SUBJECT: UPPER MIDHILL ESTATES (15-03)

I am writing on behalf of our client, Upper Midhill Estates, LLC, to transmit the information identified in the City's November 19th incompleteness determination and to request that the application for the Upper Midhill Estates Subdivision (SUB-15-03) be deemed complete. The following has been provided to document our response to each of the requests listed within the November 19th incompleteness notification. The applicant is providing all of the missing information identified in the incompleteness determination as required by ORS 227.178(2)(a).

Incomplete items per the Planning Department are as follows:

SHEET TITLE
SLOPE ANALYSIS

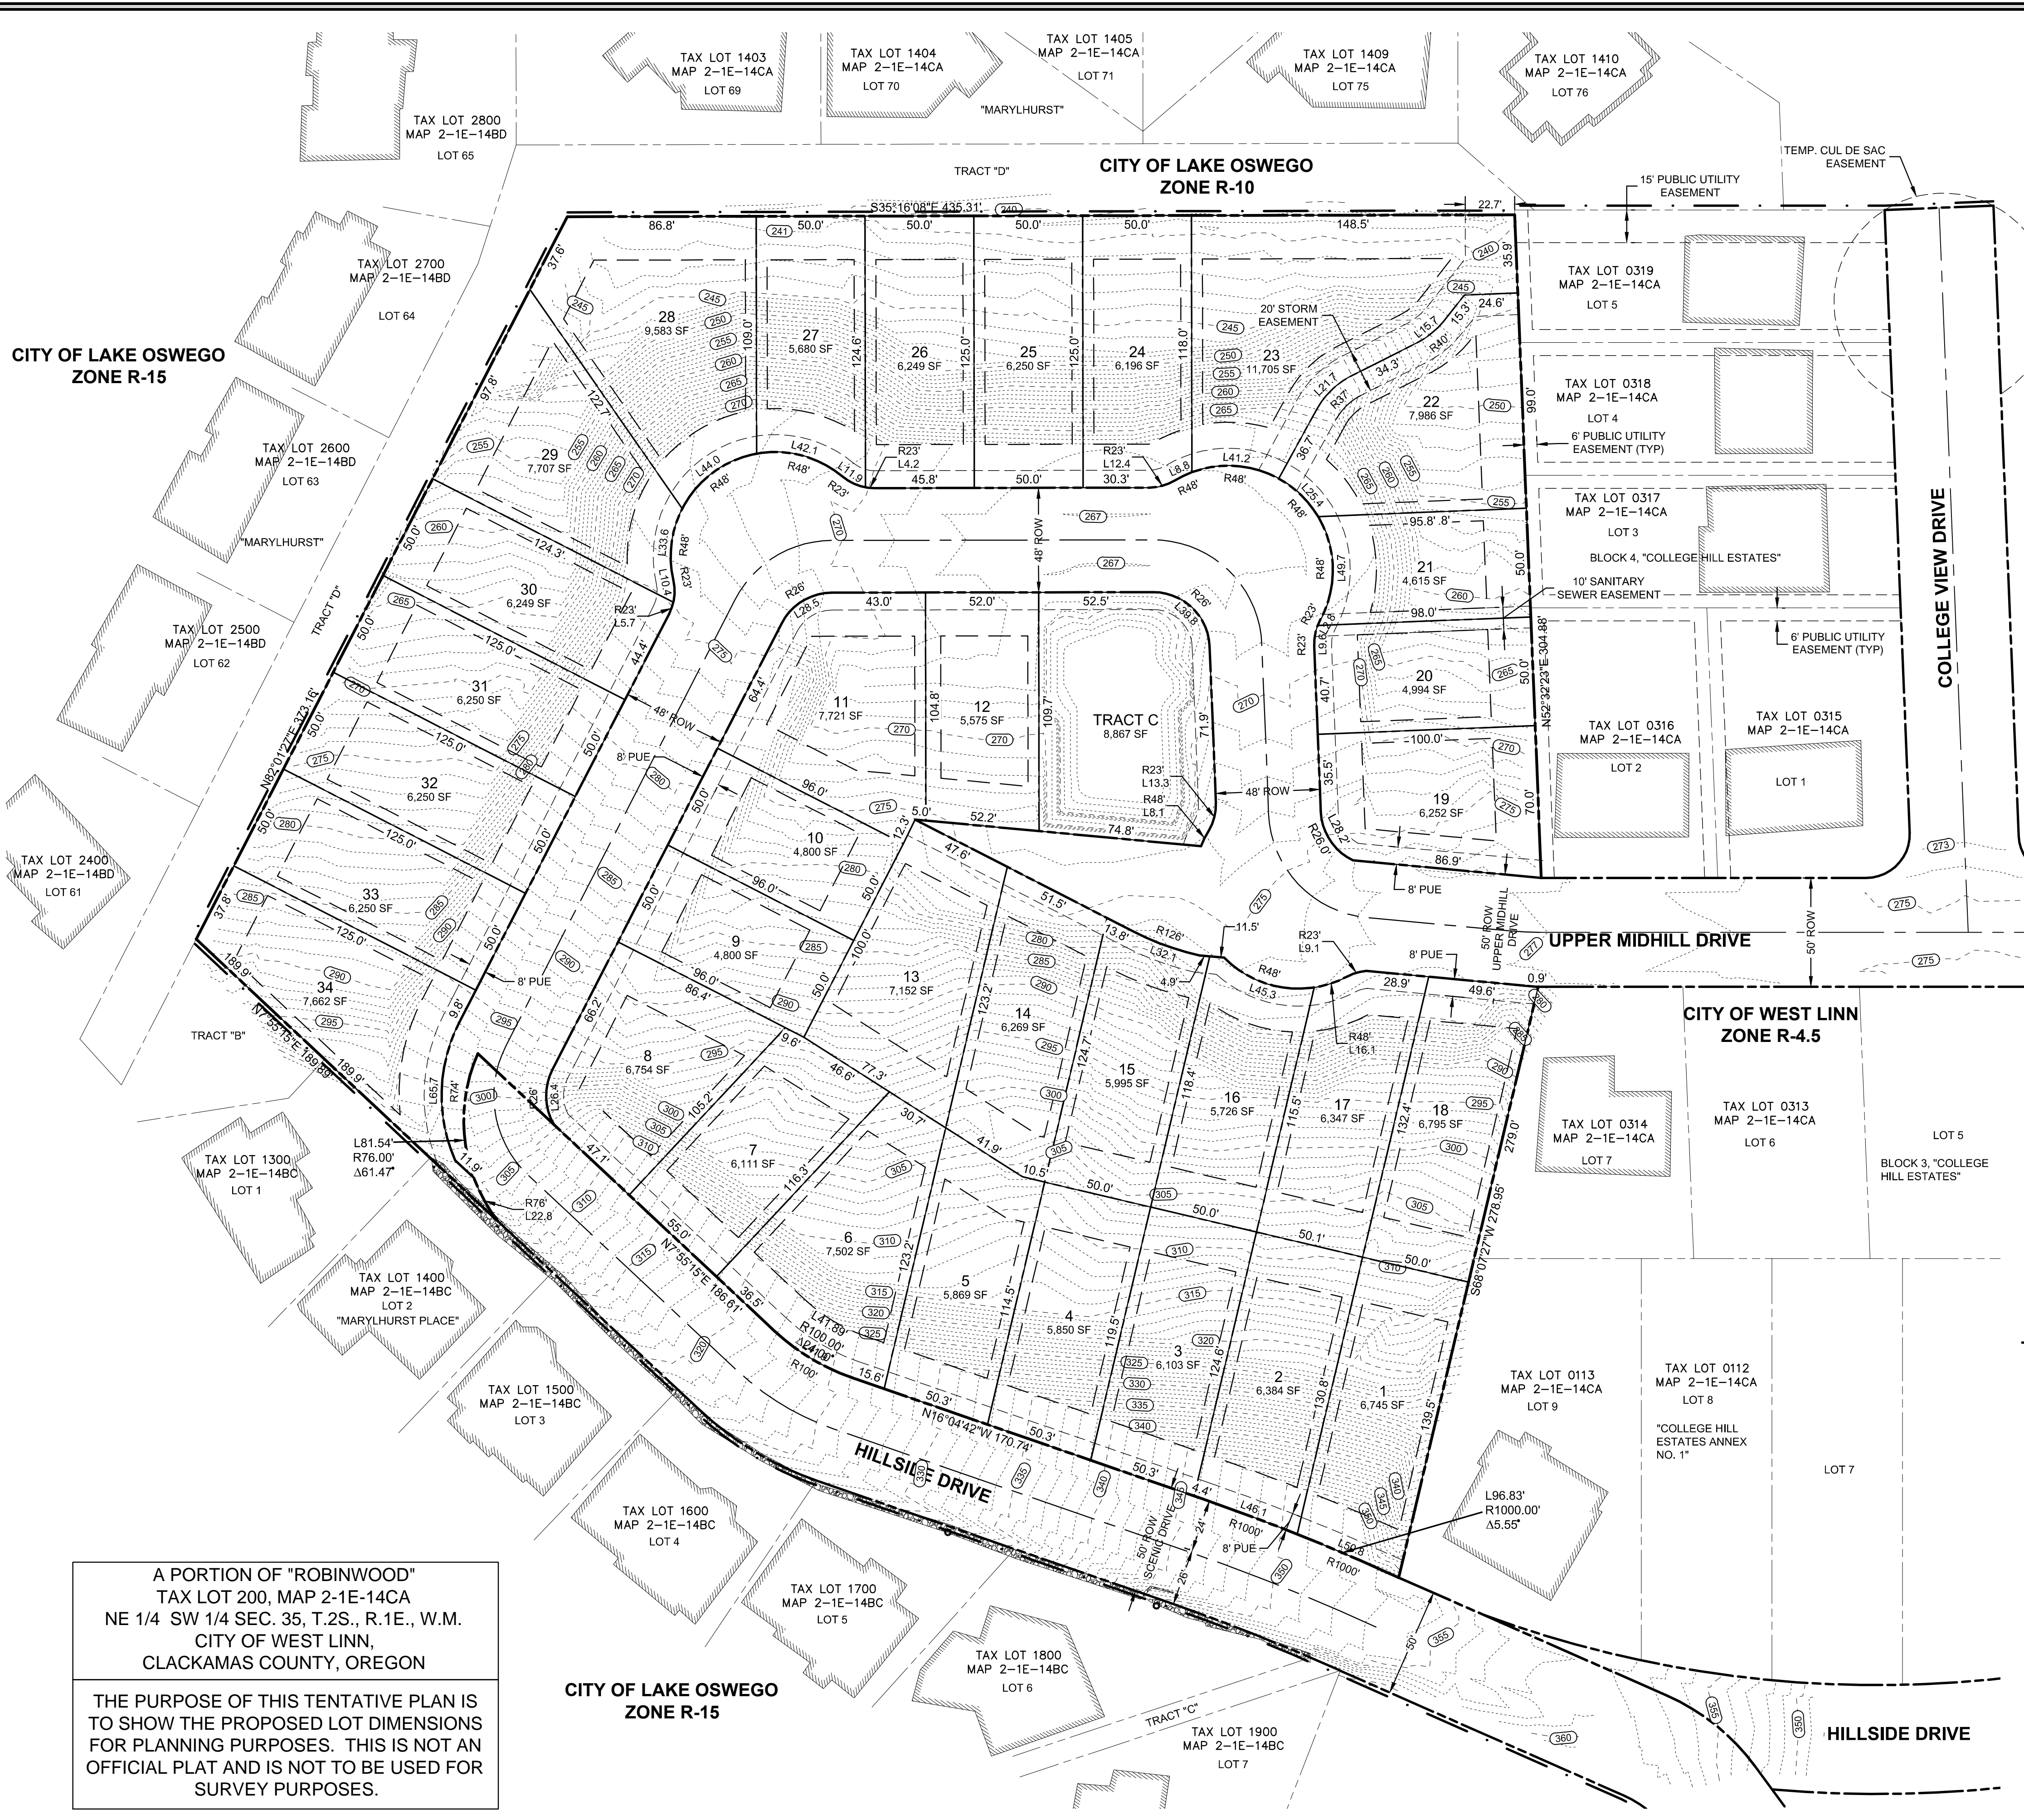
10. CDC Chapter 85.170(A) (8) Show slopes (incl. sheet C130) by breakdowns as required by 55.110(B) (3) (Type I and II lands). Also, the current slope breakdown (sheet C130) uses color/patterns that are difficult to tell apart. Please use contrasting colors or patterns.

Applicant's Finding: The slope break down has been adjusted to show Type I and II lands. The colors can be better distinguished by either the submitted 11x17's or the electronic copies of the revised plan set.

SECTION A-A: LOCAL ROAD W/ CURB TIGHT SIDEWALK (LEFT)

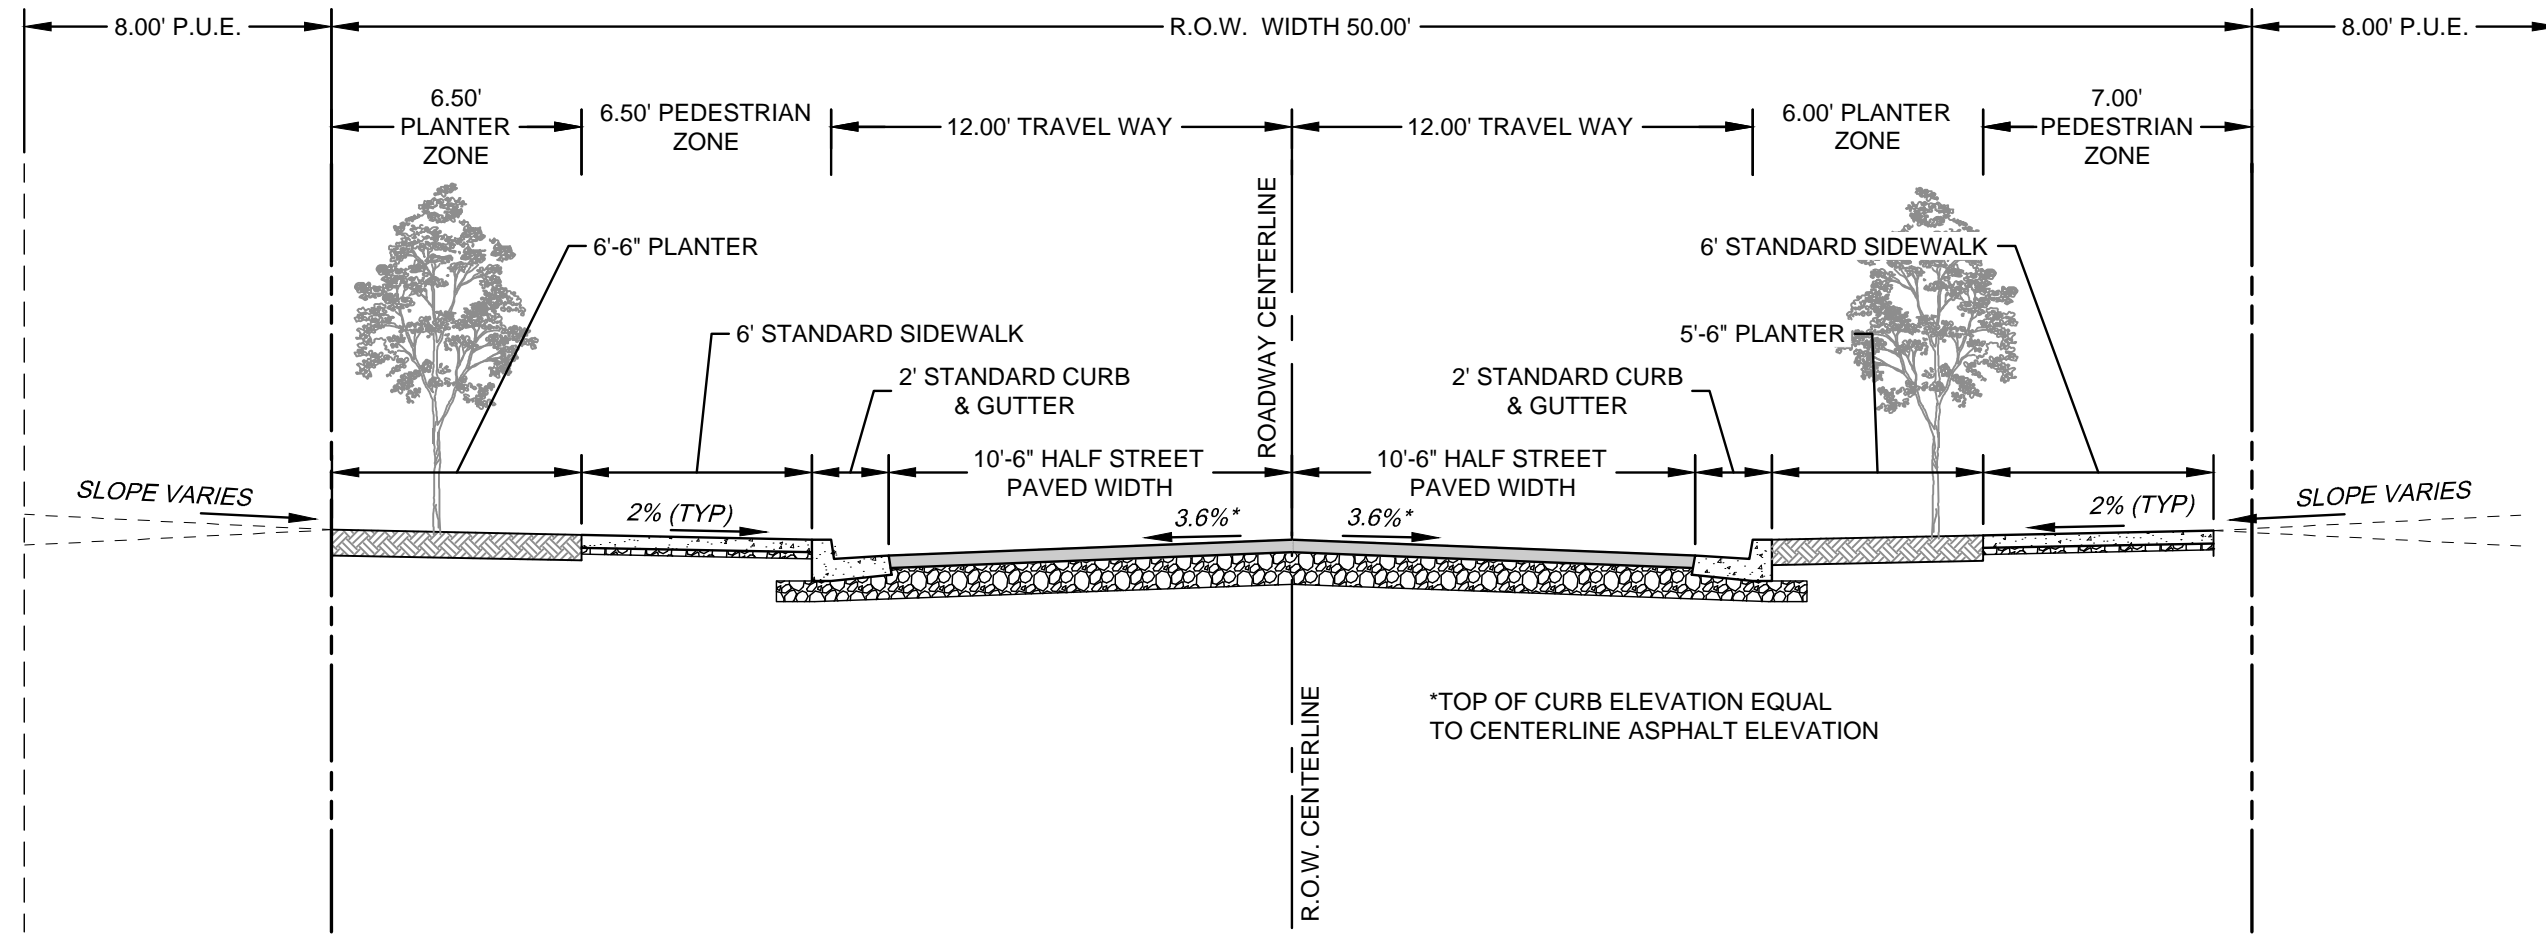
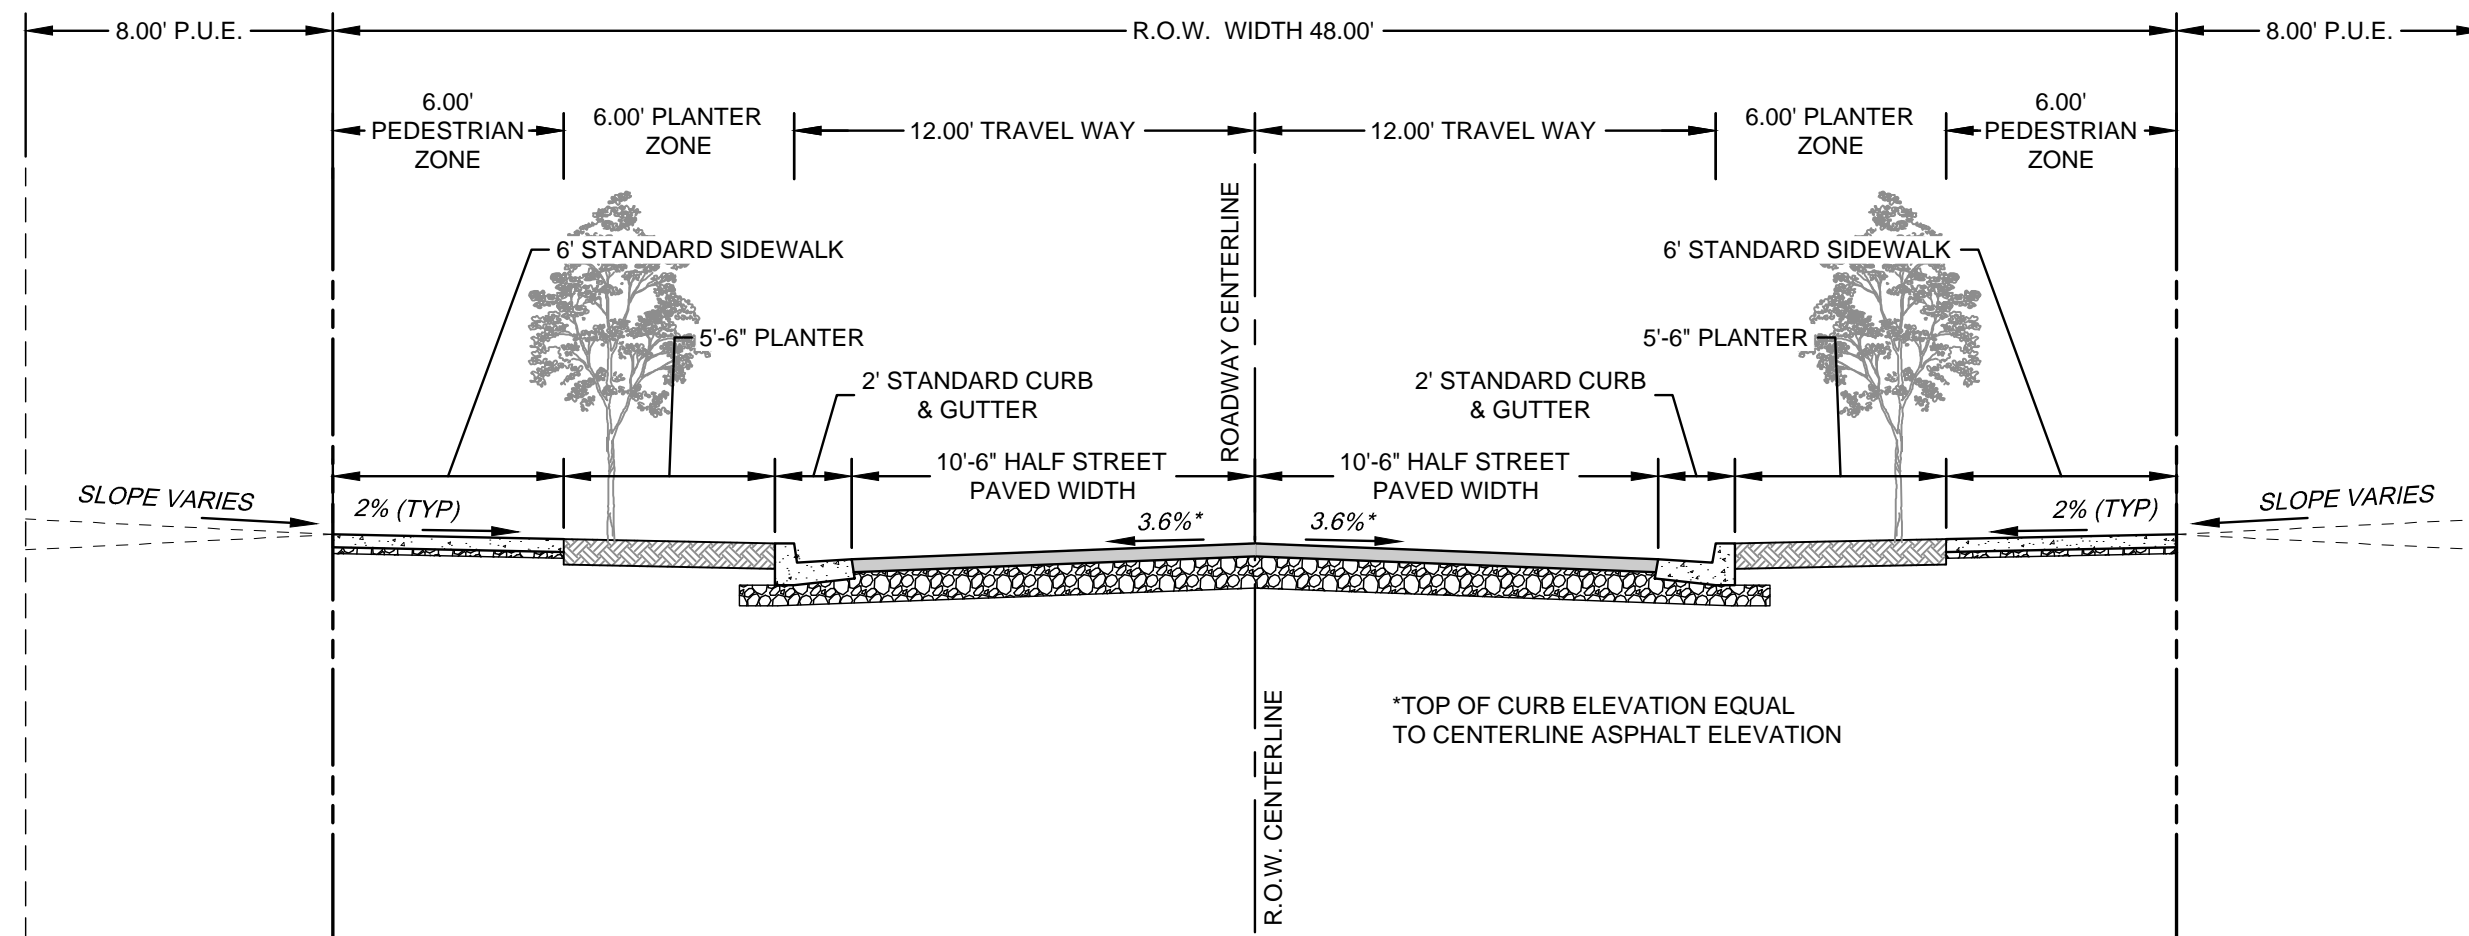
23. Sheet C201: Local Road not Neighborhood Route. 6' sidewalk on curb tight sidewalk. 6.5' including curb. Revise Section A-A. Spelling error on Section B-B.

Applicant's Finding: The title has been adjusted to read Local Road. Typical Section A-A has been adjusted to show a 6.0' sidewalk. The spelling error on Section B-B has been corrected.
